<b>Model</b>	Sorter Stapler for Thunderbird II	<b>Volt/Hz</b>	<b>Date of Modification</b>	<b>Serial Number</b>
<b>Modified Article</b>	Power Supply Cord - 220 / 240V etc.			
<b>Reason for Modification</b>	Vender change

Model: Sorter Stapler for Thunderbird II		Date: 30-Jun-97	No: 3
Modified Article: Spring - Interlock Switch		Prepared by: M.Kitajima	
From: QAC 1st Field Information Dept.			
Reason for Modification:	<input type="checkbox"/> Parts catalog correction	<input type="checkbox"/> Vendor change	<input type="checkbox"/> To meet standards
	<input type="checkbox"/> To facilitate assembly	<input checked="" type="checkbox"/> To improve reliability	( )
	<input type="checkbox"/> Part standardization	<input type="checkbox"/> Other

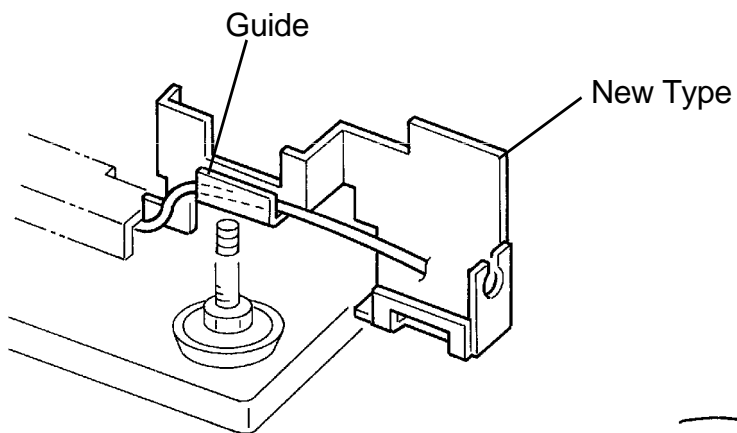
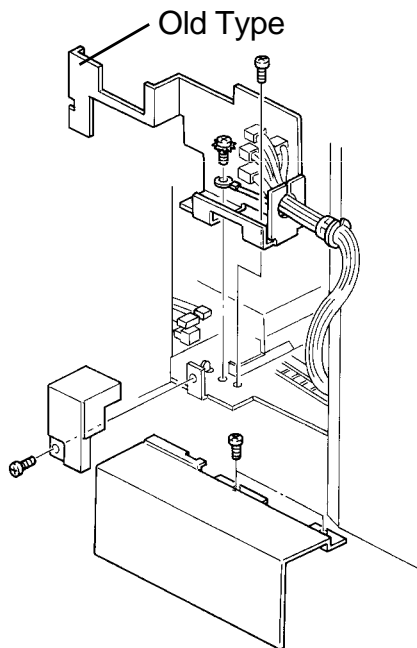
Due to a vender change, the following parts have been changed.

Old P/N	New P/N	Description	Q'ty Used	Inter-change-ability	Parts Catalog	
					Index No.	Page
28010041	AZ000036	Power Supply Cord - 220 / 240V	1 → 1	O/O	21	25
		Power Supply Cord - 250V / 10A				
16050226	16603102	Capacitor - 1000PF 50V	n → n	O/O	155	41
		Capacitor - 1000µF ±5% 50V				
16050636	16607104	Capacitor - 0.1µF	n → n	O/O	156	41
		Capacitor - 100000PF 50V
